Mitsubishi Electric AC Servo System
Sales and Service

Addition of Some Overload Protection Characteristics for AC Servo Amplifiers

1. **Target Model**
   MR-J4-B-LL

7. **Overload Protection Characteristics**

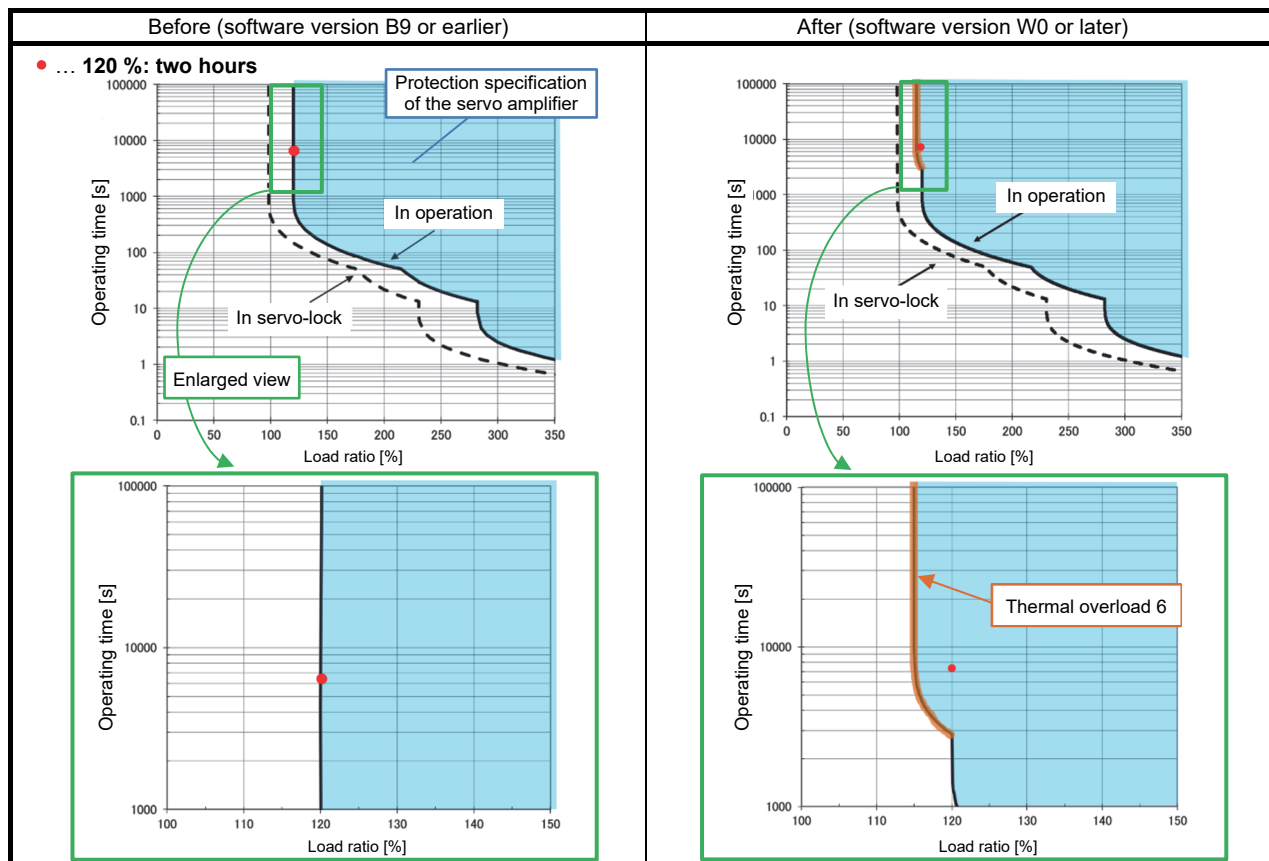
3. **Details of the Change**
   In software version W0, an overload protection curve (thermal overload 6) for the standard mentioned above will be added to the current overload protection characteristics.
   This addition will be made for the update from software version B9 to version W0.
   Along with the addition of the overload protection curve, an alarm of [AL. 50.7 Thermal overload error 6 during operation], a warning of [AL. E1.9 Thermal overload warning 6 during operation], and a parameter of [Pr. PE09 Thermal overload warning level 6 during operation] will be added.
   Refer to the following pages for details of the change.
   When [AL. 50.7] occurs, please contact your local sales office.

Figure 1. Characteristic a

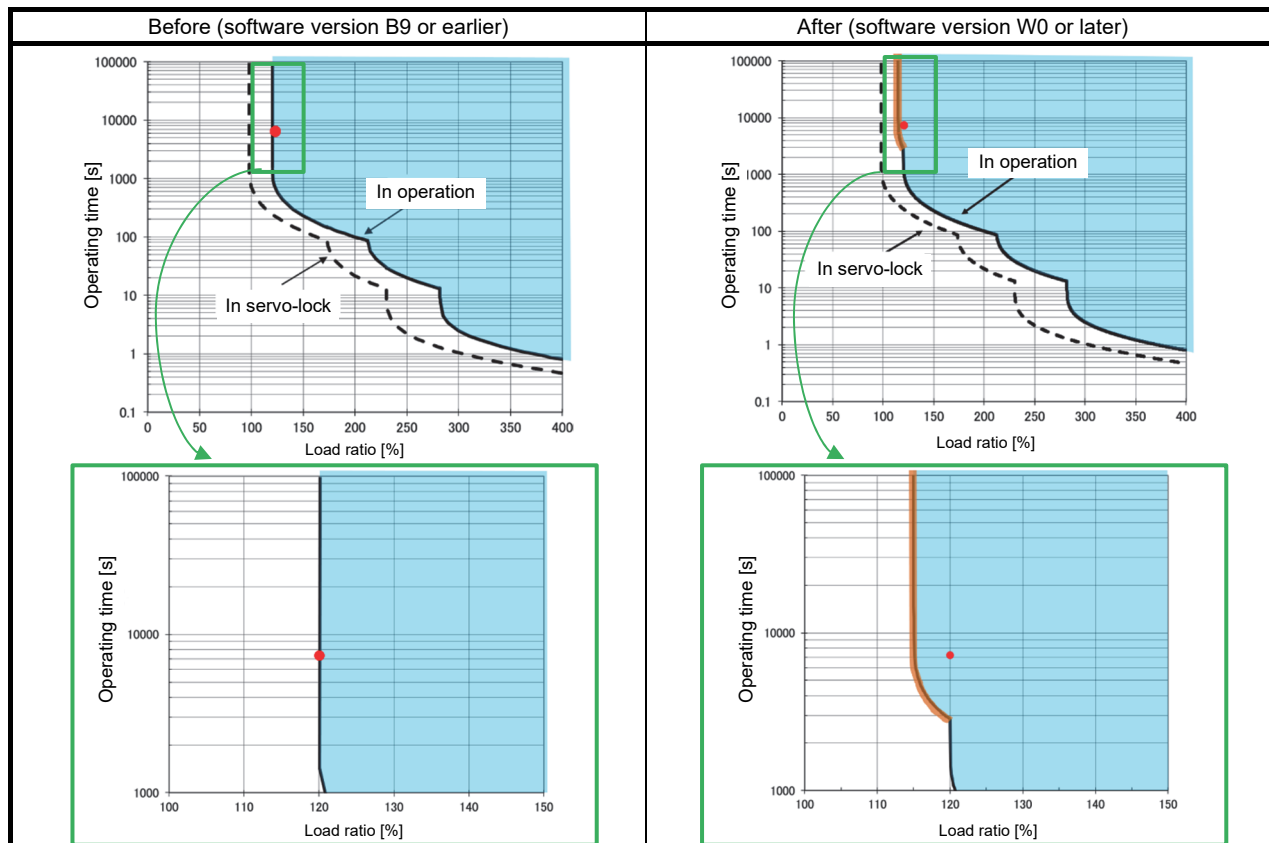
Refer to the following pages for the overload protection characteristics.
